Addendum #4
Solicitation 25-99328
Junction Avenue and St. Marie Street Reconditioning

JUNCTION AVE/ST. MARIE ST. RECONDITIONING

SHEET NO. DB03 OF DB14 SHEETS

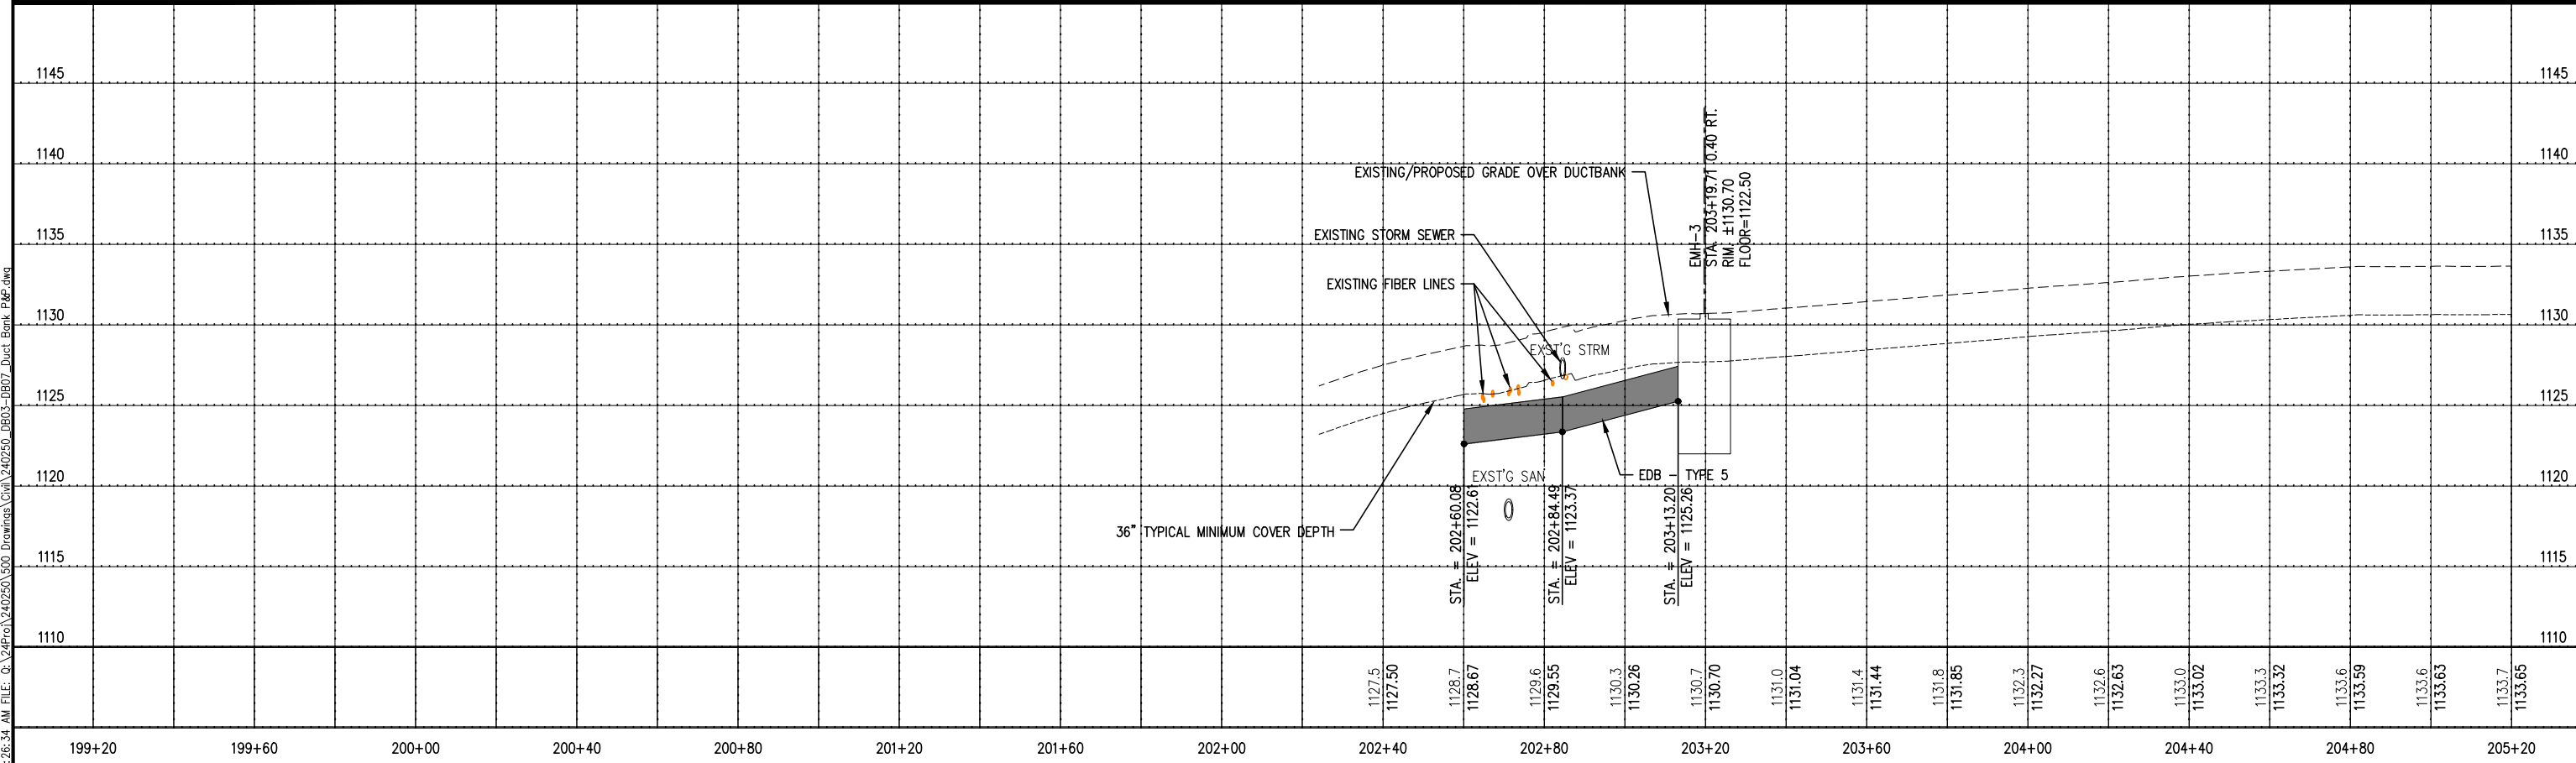
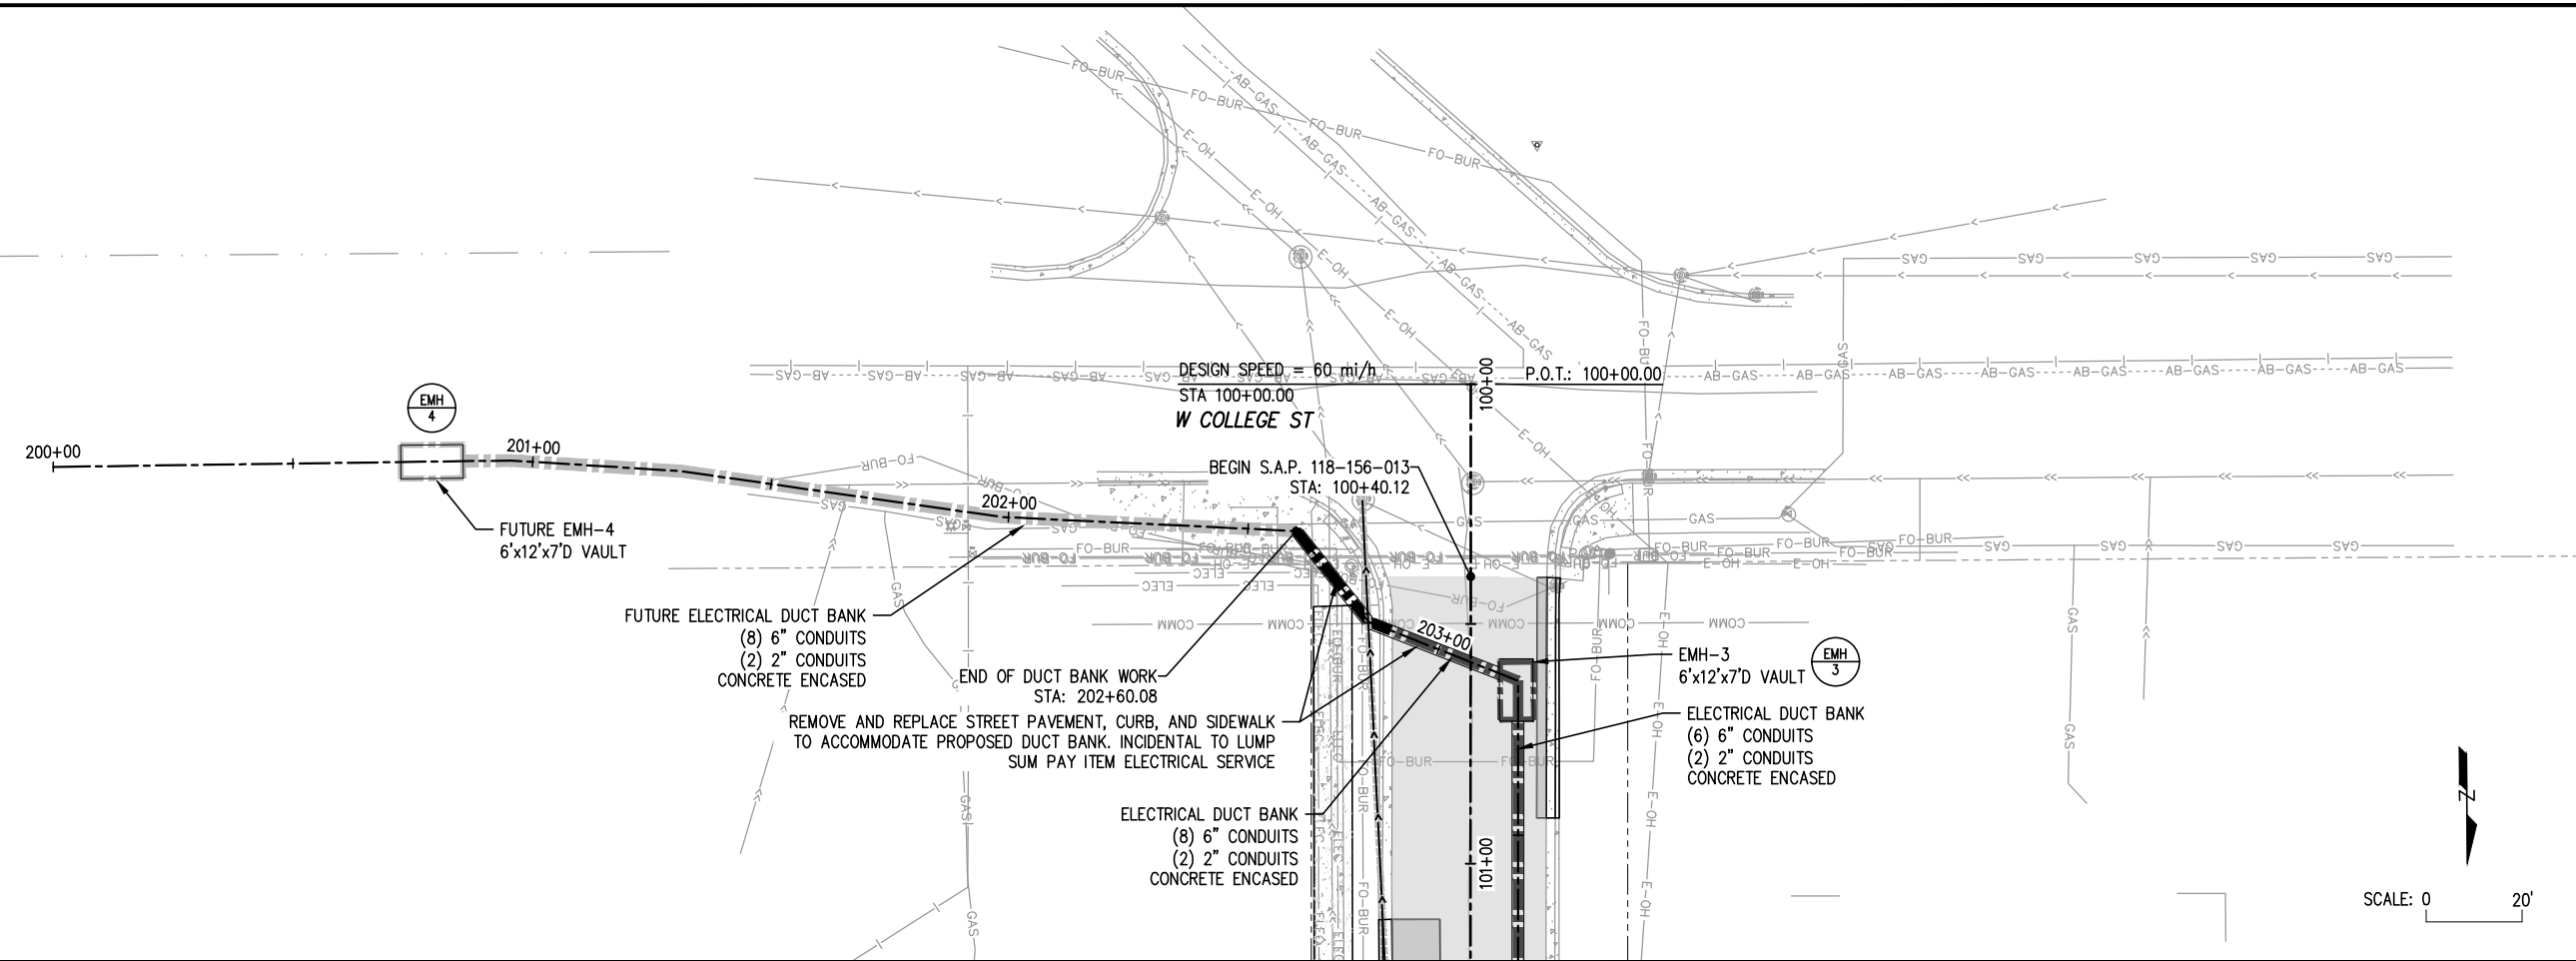
1. Drawing changes to the Electrical Duct Bank are as follows:
 - a. Duct Bank Sheets DB01- DB14; Delete sheets DB01-DB14 in their entirety and replace with revised Sheets DB01-DB14.
Revisions to sheets DB01-DB14 are as follows:
 - i. An Alignment shift along Junction Avenue that falls mostly in the street pavement.
2. Drawing changes to the STATEMENT OF ESTIMATED QUANTITIES are as follows:
 - a. Sheet 5; Delete sheet 5 in its entirety and replace with revised Sheet 5.
Revisions to sheet 5 are as follows:
